ADDENDUM # 1

RFQ# 7506367PHSE2

**CONSTRUCTION NEW LGBTQ CENTER, INCLUDE DEMOLITION RUGGELS HOUSE –
URI**

Date 12 November 2013
Project 1203 URI- LGBTQ Center
Description Addendum #1

DRAINAGE AND UTILITY PLAN

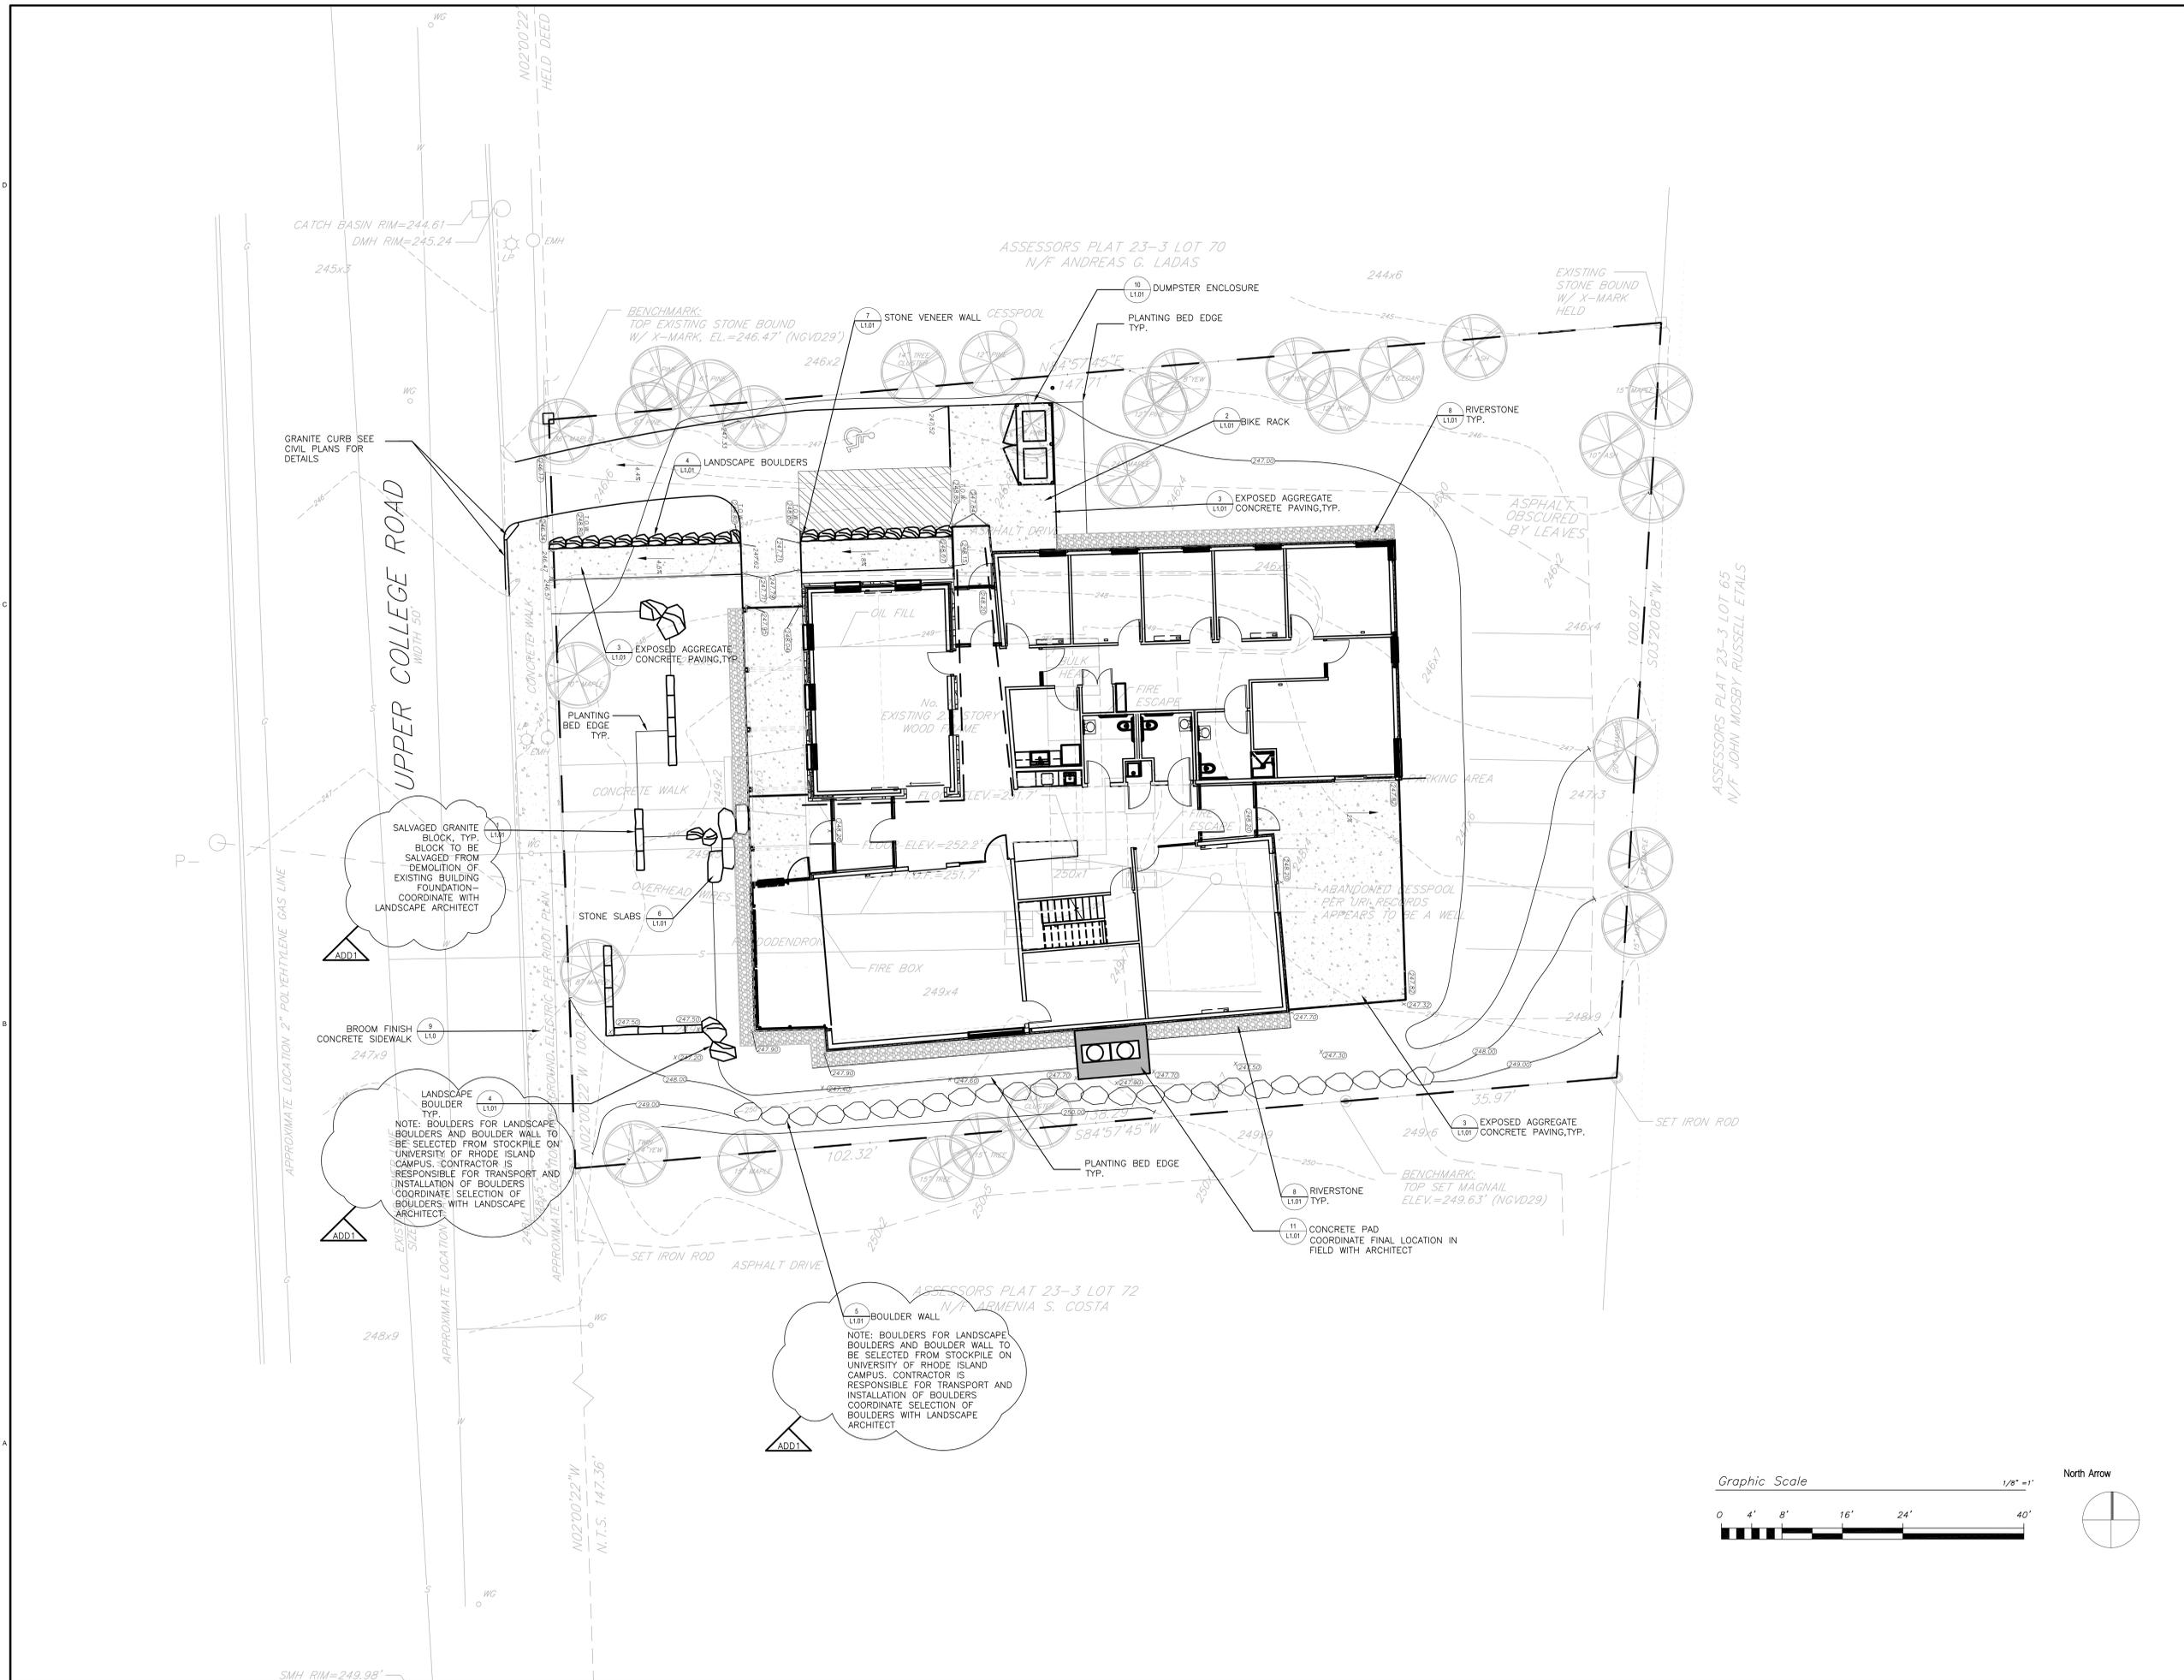
1. Alternate 1: Add water-based fire suppression system as indicated on Drawings C-0.03 and FP-1.00 and Specification 211000, and all associated work required to install a fully automatic sprinkler system. Base bid is no fire service line, no sprinkler system, and no associated water-based fire suppression system work, but includes- additional heat detectors as noted on the revised Electrical drawings.

Item #	Drawing#	Drawing Description
		<u>Action</u>
D01	C0.03	Drainage Utility and Erosions and Sedimentation Control Plan (SEE REVISION CLOUDS)
D02	L1.00	Landscape Materials and Grading Plans (SEE REVISION CLOUDS)
D03	L1.01	Hardscape Details (SEE REVISION CLOUDS)
D04	L2.00	Landscape Plan (SEE REVISION CLOUDS)
D05	L2.01	Landscape Planting Details (SEE REVISION CLOUDS)
D06	S1.0	Foundation Plan (SEE REVISION CLOUDS)
D07	G0.01	REVISE Table of Contents- Delete Sheet A11.11 Signage
D08	A9.10	Opening Types (SEE REVISION CLOUDS)
D09	A11.10	Signage (SEE REVISION CLOUDS)
D10	A11.11	Signage (DELETED)
D11	M1.00	HVAC Plans (SEE REVISION CLOUDS)
D12	M2.00	Schedules and Details-HVAC (SEE REVISION CLOUDS)
D13	E2.00	Electrical Lighting, Power and Systems Plan (REISSUED IN ENTIRETY)
D14	E2.01	Electrical Fire Alarm and Mechanical Power Plans (REISSUED IN ENTIRETY)
D15	E3.01	Electrical Details (REISSUED IN ENTIRETY)
D16	AV000	AV Drawing List and Responsibility Schedule (REISSUED IN ENTIRETY)

LANDSCAPE PLAN

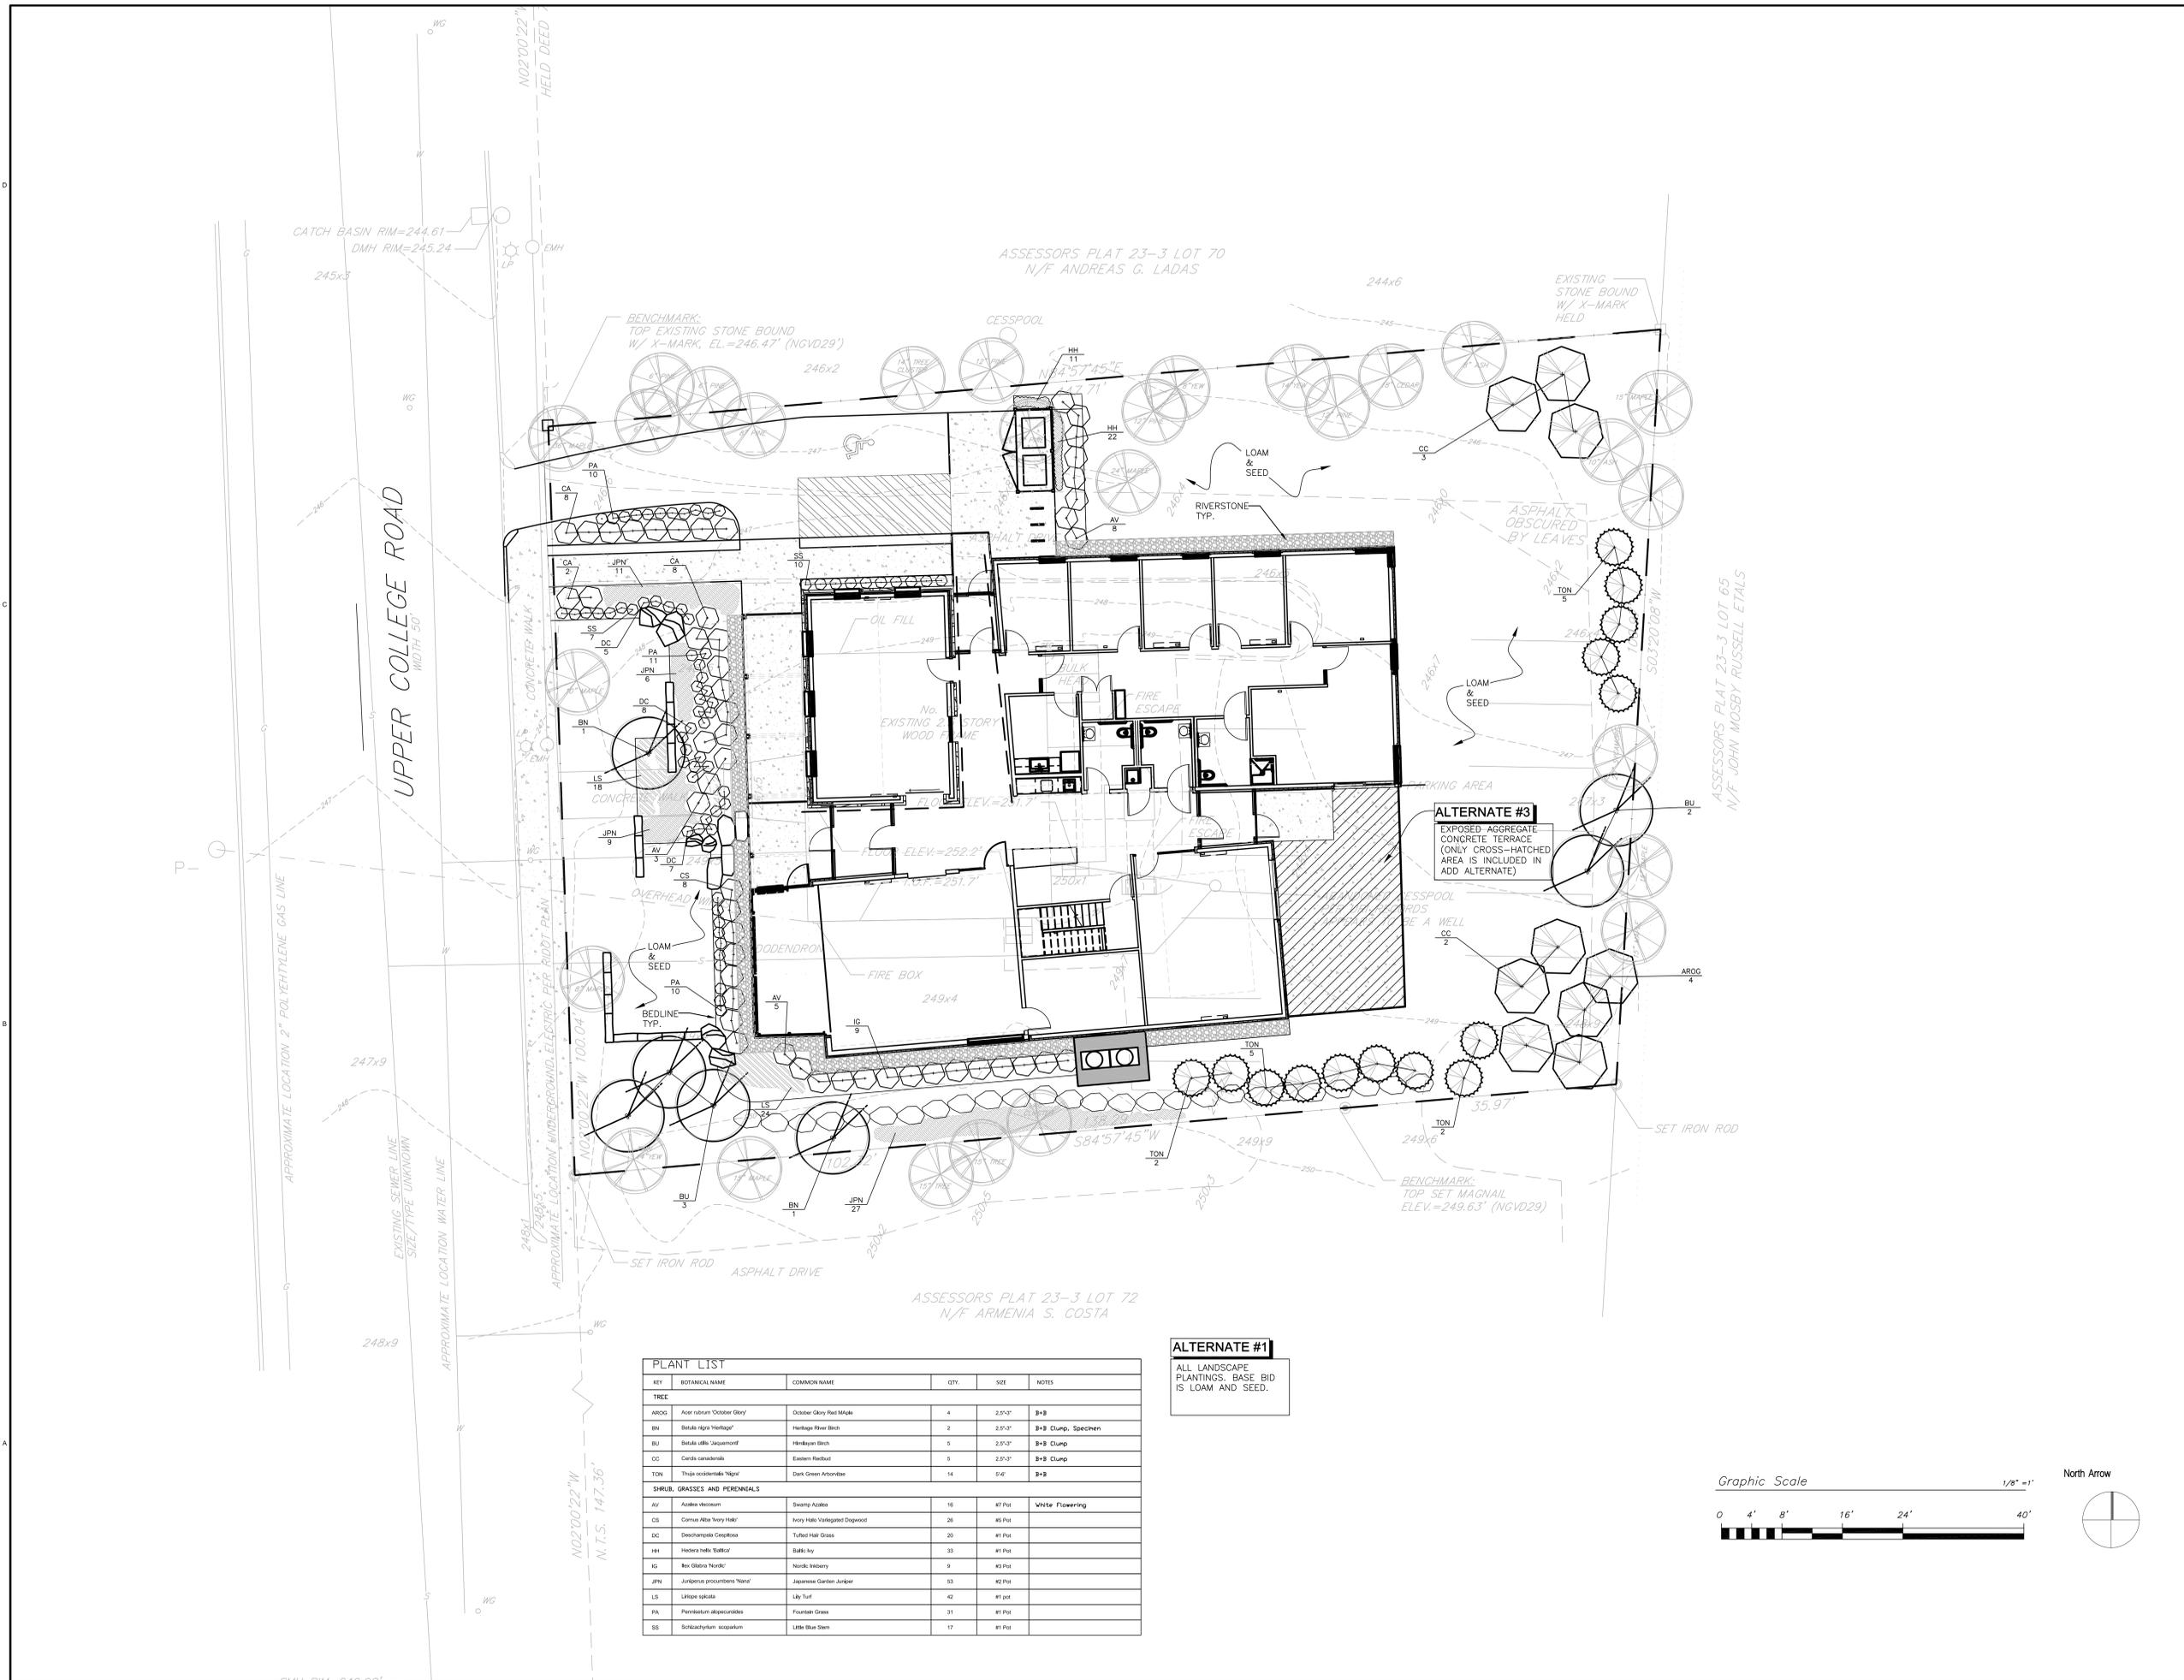
ALTERNATE #3
EXPOSED AGGREGATE CONCRETE TERRACE (ONLY CROSS-HATCHED AREA IS INCLUDED IN ADD ALTERNATE)

ALTERNATE #1
ALL LANDSCAPE PLANTINGS, BASE BID IS LOAM AND SEED.
